# Access Compliance Report

## Public Rights-of-Way

Intersection ID: 50940	Main Street: BLAIRBETH_ST	Cross Street: ARDREY_KELL_RD	Location: NW
ADA ID: 6D4B4893EF1A	Ramp Type: Perp	Initial Pass/Fail: Fail	Overall Compliance: No
		Severity Score: 1.25

#### Codes/Mitigation Info/Possible Solution

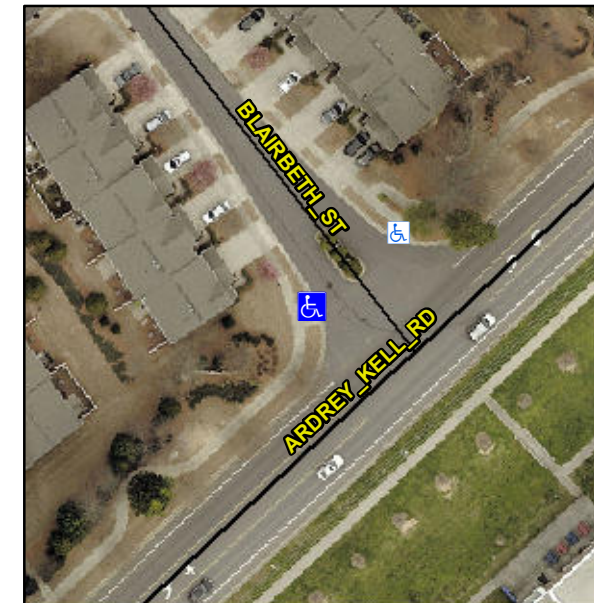
**Not Found, R304.5.3**

Compliance	Description	Data	Compliance	Description	Data
N/A	Ramp Length (in)	108.5	Yes	Ramp Slope (%)	5.9
Yes	Ramp Width (in)	48.0	No	Ramp XSlope (%)	2.5
N/A	Flare Type LT	N/A	N/A	Flare Type RT	N/A
N/A	Flare Slope LT (%)	N/A	N/A	Flare Slope RT (%)	N/A
N/A	Flare Traversable LT?	N/A	N/A	Flare Traversable RT?	N/A
N/A	Landing Length (in)	N/A	N/A	DWS Provided?	N/A
N/A	Landing Width (in)	N/A	N/A	DWS Contrast?	N/A
N/A	Landing Slope (%)	N/A	N/A	DWS Length (in)	N/A
N/A	Landing X Slope (%)	N/A	N/A	DWS Full Width?	N/A
N/A	Landing Curb? (Y/N)	N/A	N/A	DWS Offset (in)	N/A
N/A	Shared Landing?	N/A			
N/A	Gutter Ponding?	N/A	N/A	Gutter Slope (%)	N/A
N/A	Gutter Lip Ht (in)	N/A	N/A	Gutter X Slope (%)	N/A
N/A	Painted X Walk1?	No	N/A	Painted X Walk2?	N/A
	X Walk 1 Direction	To NE		X Walk 2 Direction	N/A
N/A	X Walk 1 Width (in)	N/A	N/A	X Walk 2 Width (in)	N/A
	X Walk 1 Slope (%)	3.9		X Walk 2 Slope (%)	N/A
	X Walk 1 X Slope (%)	0.1		X Walk 2 X Slope (%)	N/A

**Remove & Replace Entire Ramp.**
